ADDENDUM NO. 2

Contract No. 2020-0173
Project Freedom Ballfields

Date of Issuance 8/4/2020

You are directed to make the following changes in the Contract Documents:

1 CUPOLA SECTION - BUILDING A & B
 A7.03 3/4" = 1'-0"

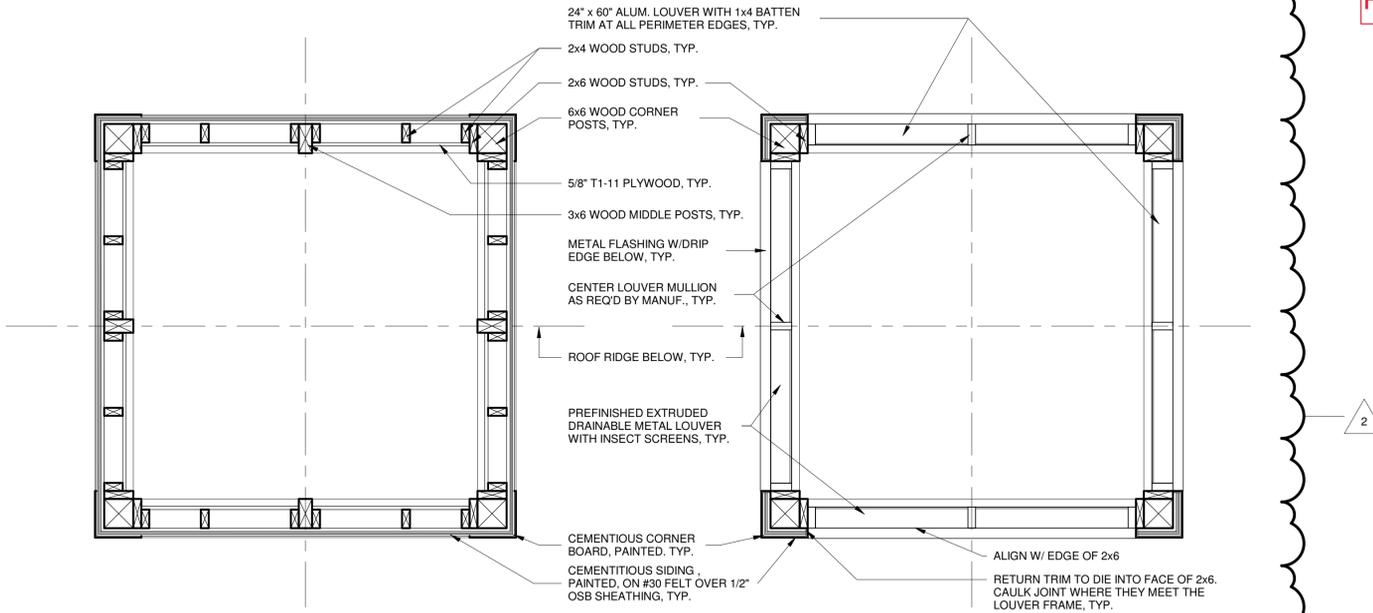
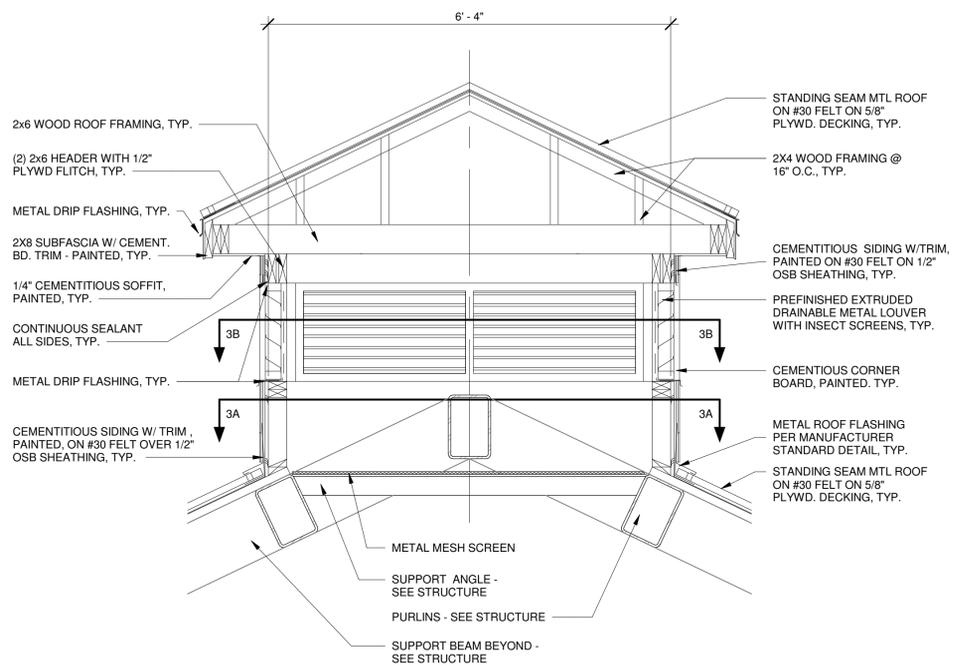
2. **Questions: The elevation on A3.A5 shows the louvers as being 5'-0" wide by 2'-0" tall (1 louver per elevation). Detail 1 and 3 on A7.03 shows louvers as 2'-6" wide by 2'-0" tall (2 louvers per elevation with wood blocking in between) Please advise on which is correct?**

Answer: The elevation is correct. See revised sheet A7.03.
3. **Questions: Sheet E1.1, Note 3 call for empty conduit with pull strings to the scoreboard for future scoreboard control wiring. Sheet C4.11 calls for a scoreboard with wireless controls. Can these conduits and pull strings be deleted?**

Title: **ECHELON MAJESTIC 3-RAIL**

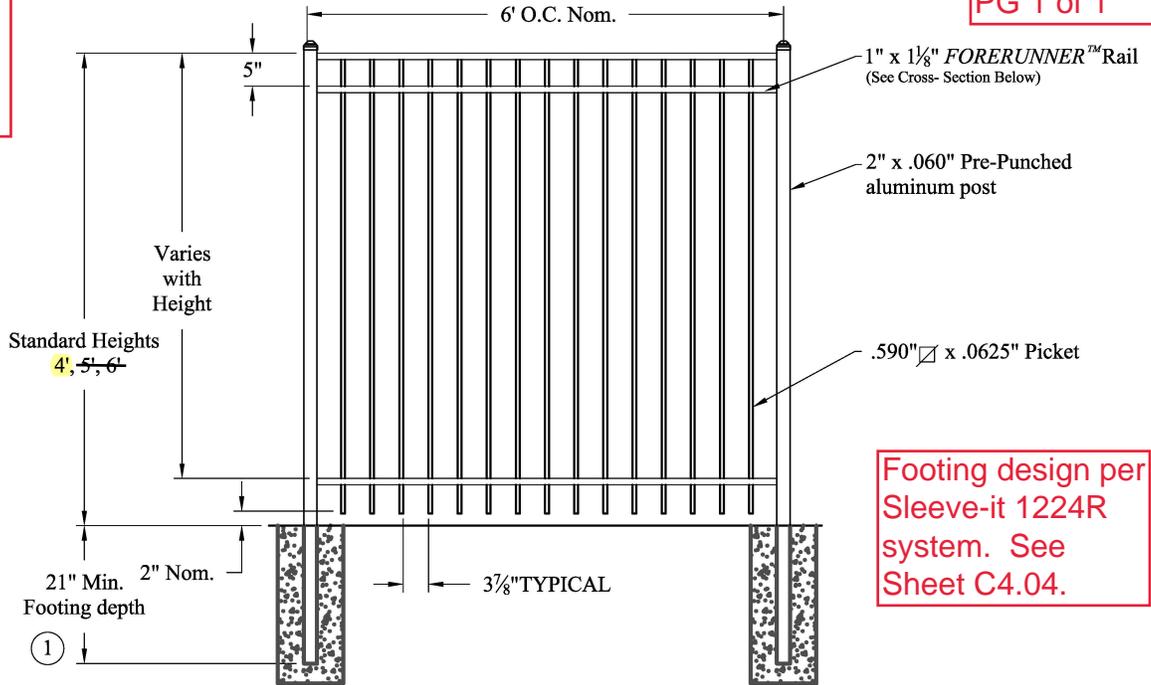
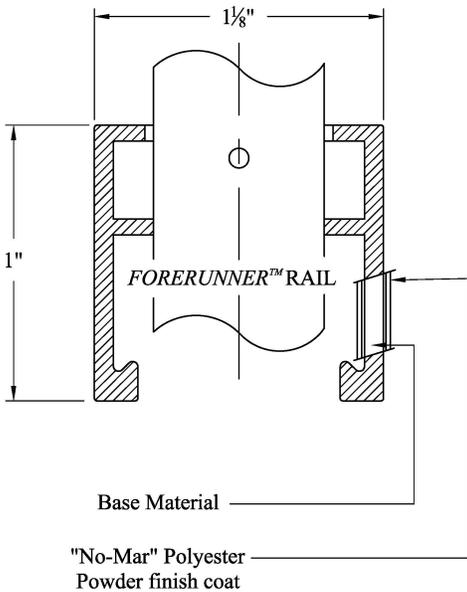
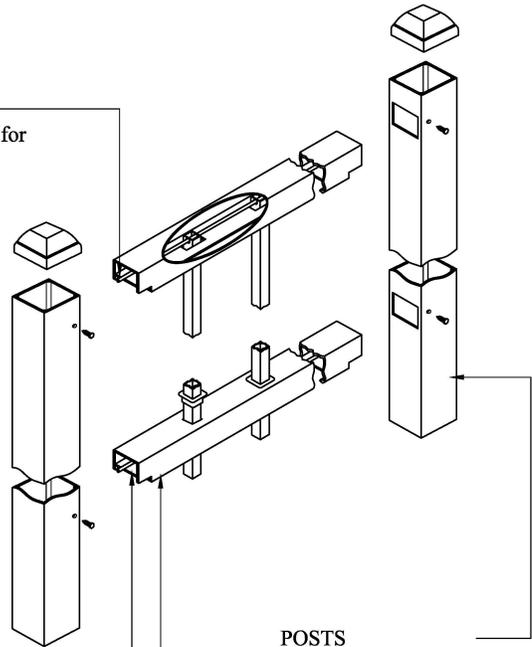
- 13. Questions: Guard Rail at Wall Sheet C4.04 - Please provide height and specification for fence at Keystone wall.**

Answer: Ameristar Echelon Majestic 3-Rail shall be used. See Attachment C for height and specification for the fence.

Fence to be installed with Keystone segmental retaining wall. See sheet C4.04.

Footing design per Sleeve-it 1224R system. See Sheet C4.04.
